**AMENDMENTS TO THE DRAWINGS:**

Attachments: Replacement Drawing Sheet (Fig. 5)

FIG. 5

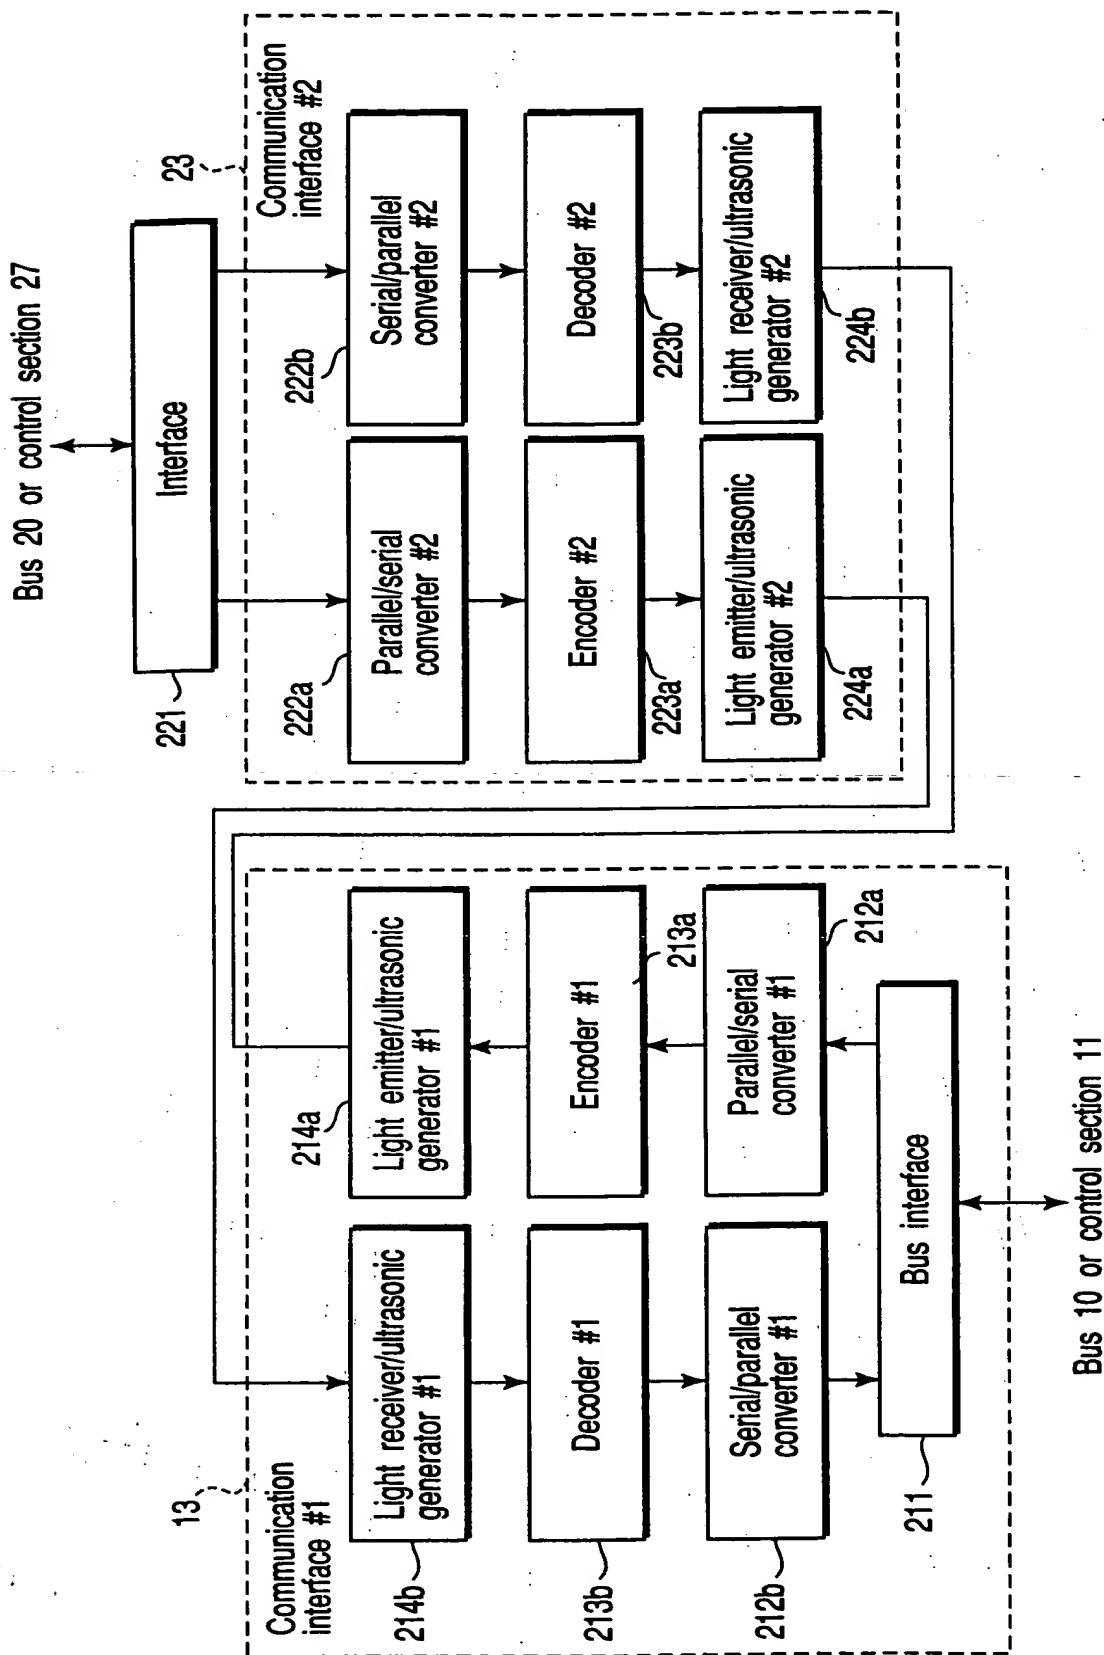
The attached replacement drawing sheet includes a change to Fig. 5. Fig. 5 has been amended to correct the wording from "Communicartion interface #1" to --Communication interface #1--.
